Product hierarchy no. *				Part no.	SBU	Type / Description	Customer part no.
SBU	PG	PUG	Type				
80	084	002	0000006516	See list below	800840020000006516	FMBB NEO

2 Type of change

Product Change Notification					PCN FMBB NEO Redesign		
owner	creation date	release date	released by	change order no	rev	page	D10-021-376
segatro	10.01.2018	10.01.2018	romanogu	2014495	B	1 of 4

Old product appearance	New product appearance

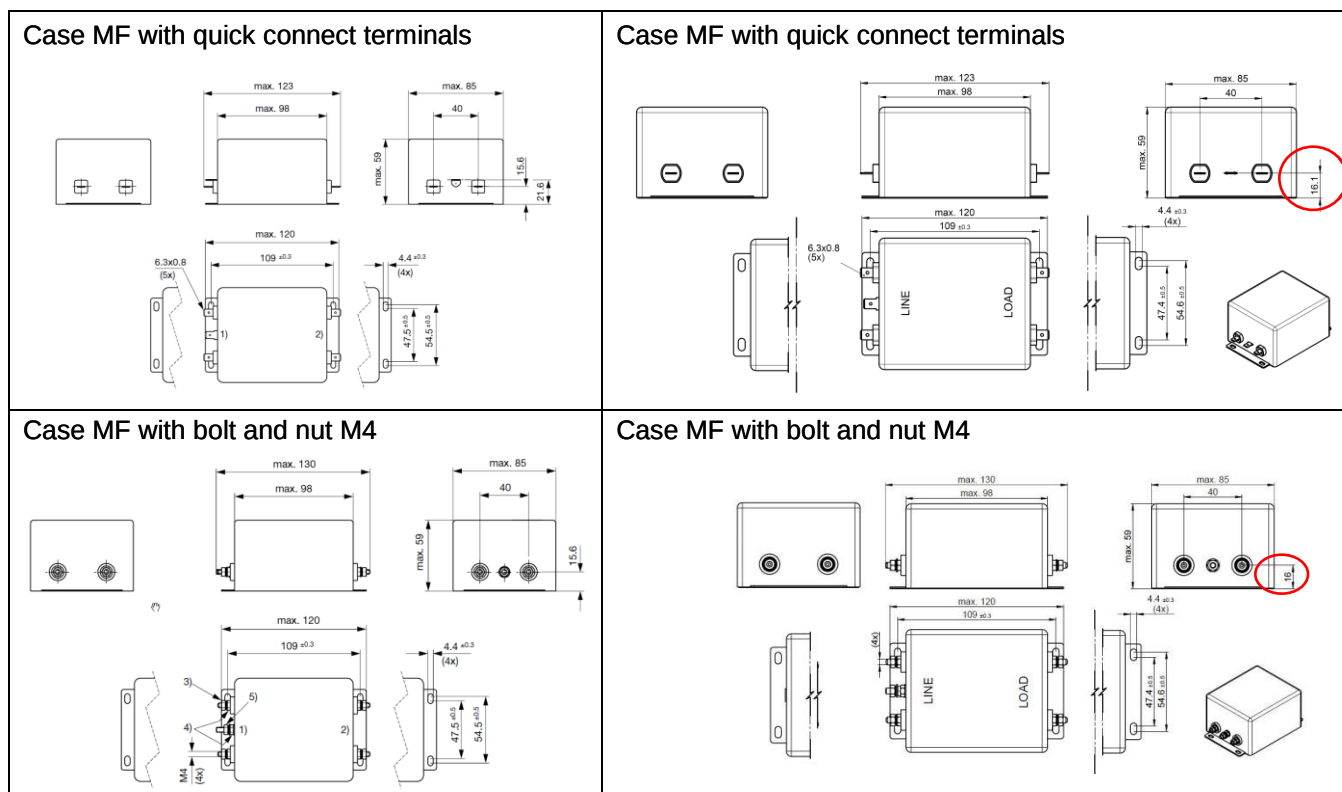
- Change of product appearance due to new nickel plated case instead of aluminium case and different shape of quick connect terminals see photo below
- Change of factory code from SK to SC and origin from SK to CN on product and packaging labels, see below
- New climatic category indication on product label, see below
- Change of mechanical drawings, product appearance only, no dimensions, see below

Old product rating	New product rating
Climatic category 25/100/21	Climatic category 40/100/21

- Nickel plated case instead of aluminium case
- New cases are provided with a bottom cover
- Different shape of external quick connect terminals
- Production transfer from Slovakia (SK) to China (CN)
- Change of climatic category, from 25/100/21 to 40/100/21
